HP-SCR NOx sensor junction box

Owners and Operators of MAN B&W Two-Stroke Marine Diesel Engines

All MAN HP-SCR engines

20 January 2020

Figure 1: Temperature fluctuations caused by the internal heating of the NOx sensors

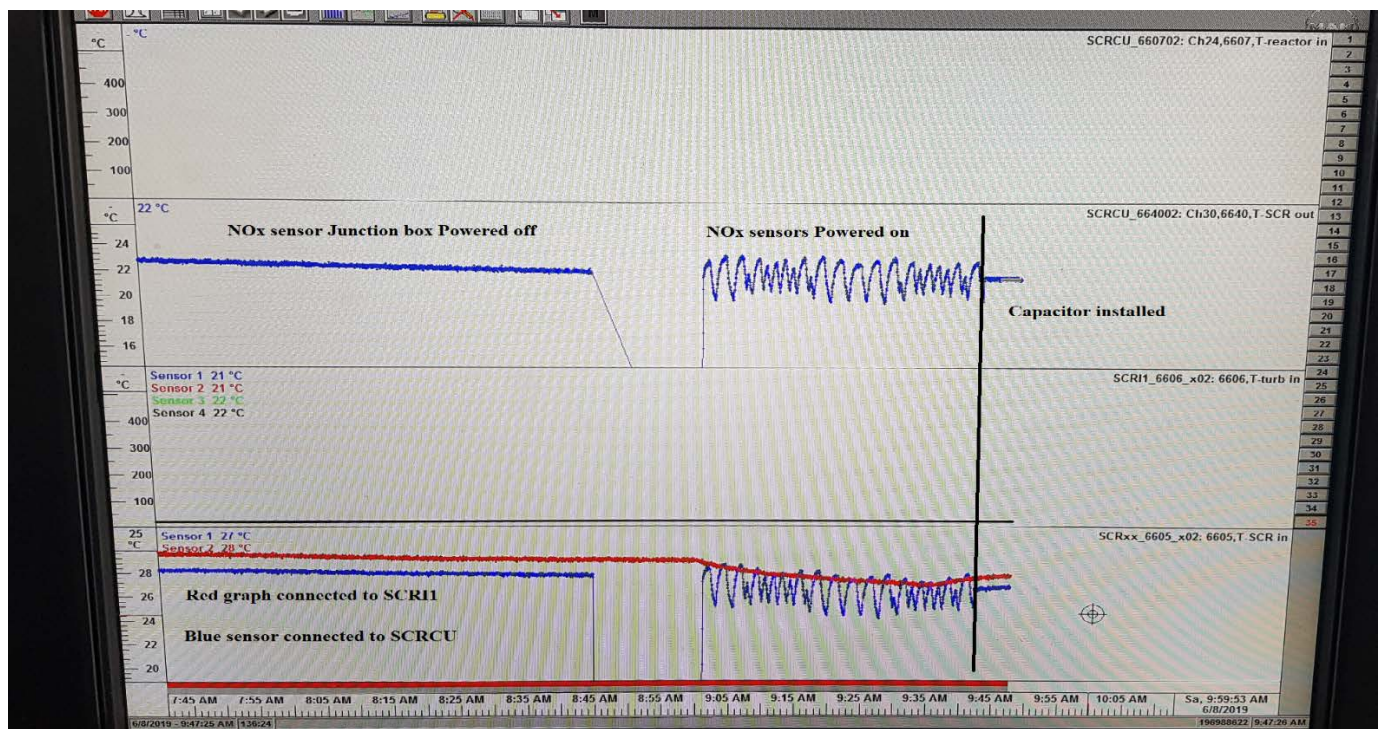
We have recently discovered that the internal heating process of the NOx sensors in SCR installations consumes high current peaks, which lead to voltage drops. These drops result in fluctuations of the temperature measurement on SCR installations connected to the same MPC as the NOx sensors; SCRCU.

Due to the disturbances, SCR operation becomes troublesome in especially low load operation where the system believes temperatures are not high enough for minimum dosing and goes from Reactor Ready state in to Heating, thus, preventing NOx reduction.

As a countermeasure, a large capacitor has been added to the NOx sensor junction box. This stabilises the voltage and reduces incorrect oscillations measured to a minimum.

| No capacitor installed | Capacitor installed |

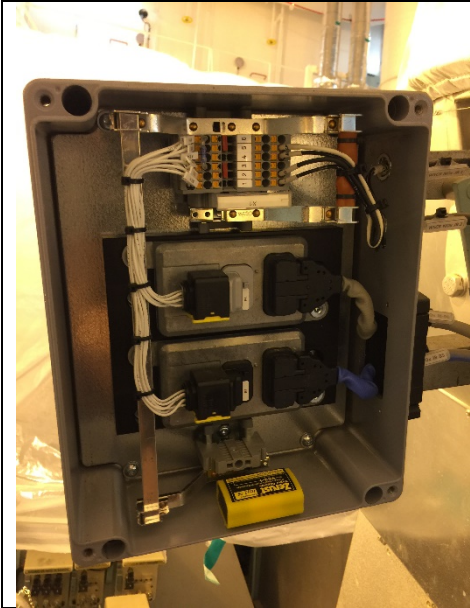
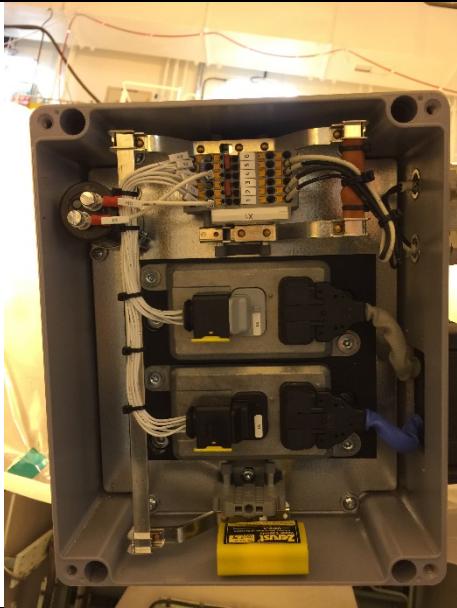
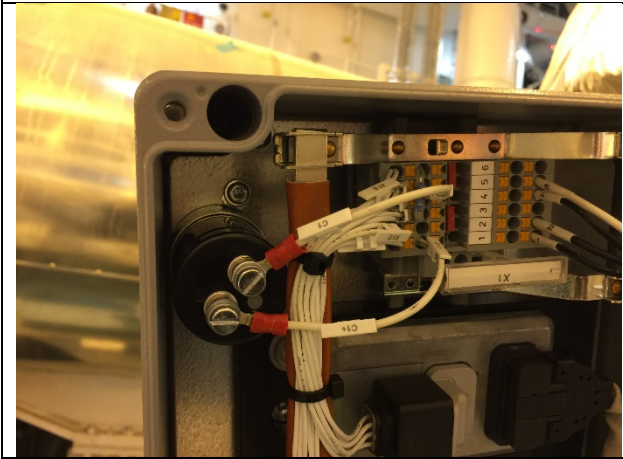
All new SCR engines with order date from August 2019 will already have the capacitors installed from production, but existing vessels will have to install one in service. Due to the limited work involved, we kindly request Crew to install on their own vessel upon receiving the upgrade kit, which will be sent to all Owners with a HP-SCR engine in service. We recommend Owners to open up NOx junction box to confirm whether a capacitor is installed. If in doubt whether one is installed, you can easily open the junction box, which is only secured with four screws and check it.

Figure 2: Capacitor upgrade kit

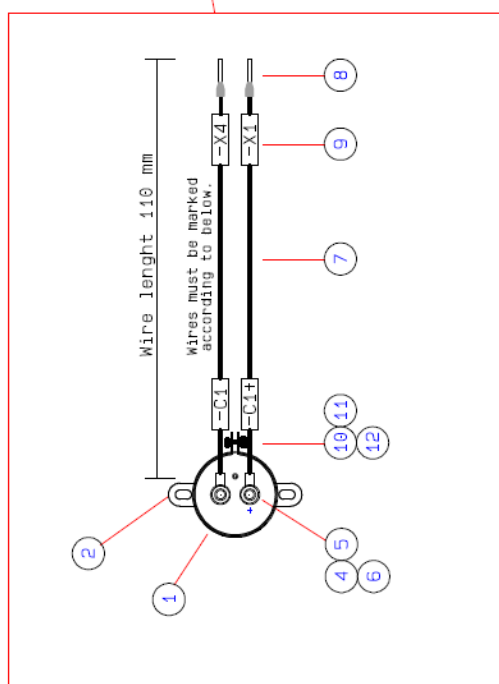
Full drawing package will be included in the upgrade kit together with screws and securing for the capacitors.

Practically, it is advised to pre-drill a small hole for the self- drilling screws (despite their name) as this speeds up the fastening process. Without the pre-drilled holes, or using the self-drilling screw as a drill bit, it becomes very difficult to penetrate the plate of the junction box.
